# Issues with TDECQ and the Associated DFE

IEEE 802.3dj Ad Hoc

21 April 2026

Comments Addressed: I-92, I-180, I-220, I-224, I-391, I-393, I-394, I-395, I-396, I-397, I-415, I-463

Figure 180-11—Illustration of the TDECQ measurement

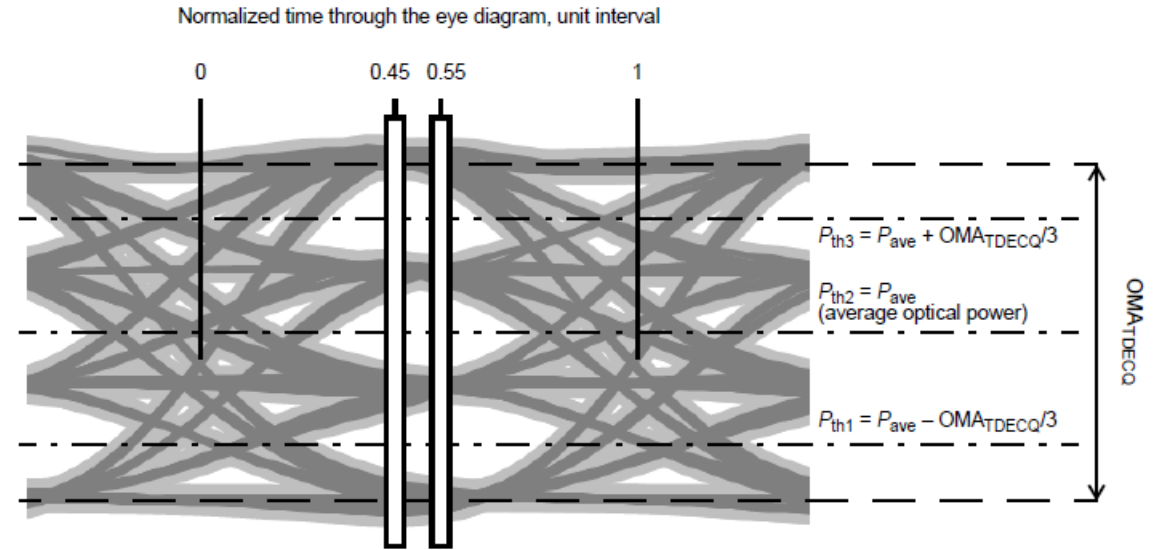
*“... are measured using samples taken at  $\pm 5\%$  UI from the equalizer optimization sampling phase.”*

Two vertical histograms are measured ~~through the eye diagram, nominally centered at 0.45 UI and 0.55 UI.~~ Each of the histogram windows spans all of the modulation levels of the eye diagram, as illustrated in Figure 180-11. The precise time position of the pair of histograms is adjusted to minimize TDECQ while keeping the histograms spaced 0.1 UI apart.

Figure 180–10—TDECQ reference equalizer functional model

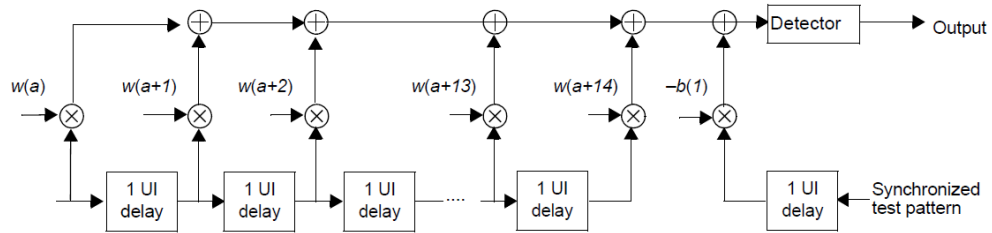
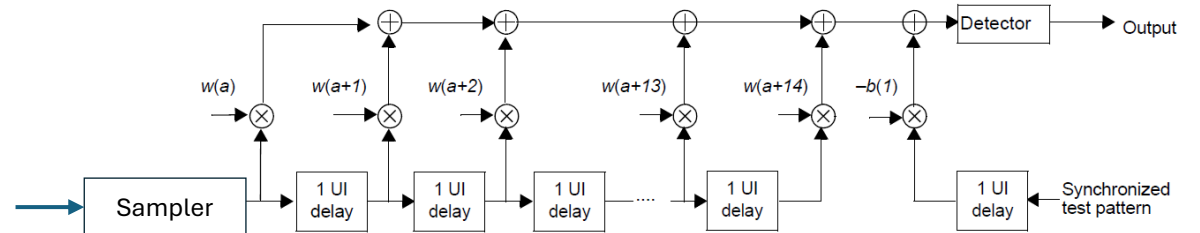
Comments I-394 (Swenson), I-396 (Swenson)

Suggested remedy: Delete the eye diagram. Or if we keep it, add the “bat-wings”.

- A discrete-time equalizer has no eye diagram
  - A discrete-time signal is not defined in between samples
- Or you could say it has a “boring” eye diagram if you maintain that the signal stays constant between samples

- 1) Continuous time equalizer

- Taps are adjusted based on 1UI - spaced samples
- Components shown are ideal (infinite bandwidth)

- 2) Discrete time equalizer

- 1UI –spaced Sampler is at the input
- For a given tap setting, the phase of the sampler can be swept to produce the eye diagram

Figure 180-11—Illustration of the TDECQ measurement

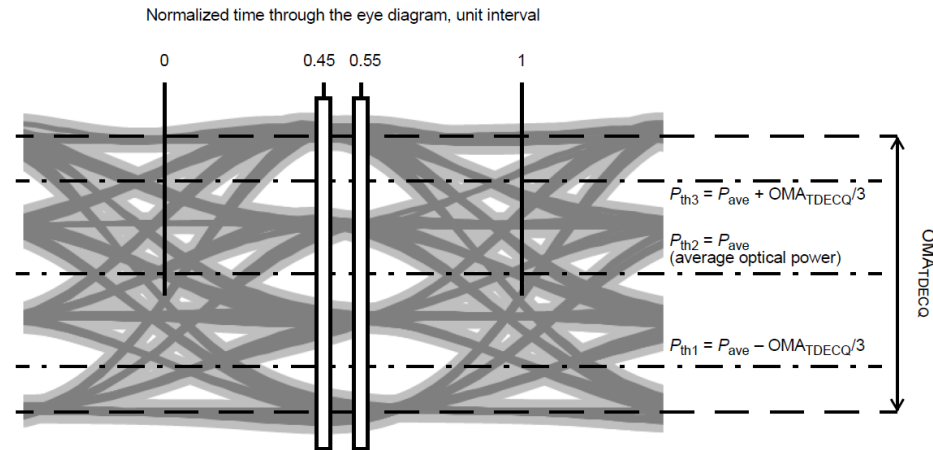
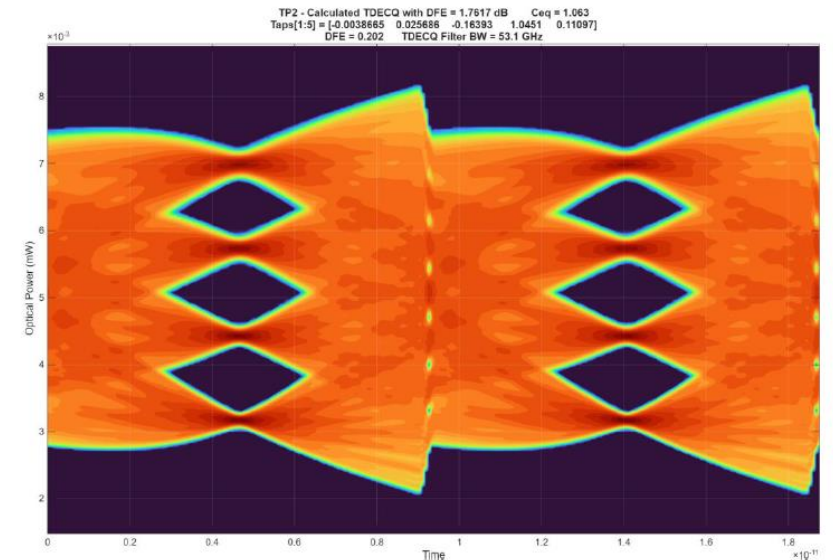
- However we define it, we need to include the “bat-wing” if we show the eye diagram
  - This is a unique feature of the DFE eye diagram. The amount added to the waveform is constant over 1UI.
- Timing: The value must change outside of the two histogram windows
  - Nominally 1/2 UI from the center eye opening is a good choice
  - We need to say something about this in the text
    - Perhaps “1/2 UI from the nominal point at which the TDECQ is measured”
  - This needs better description in the text and figure
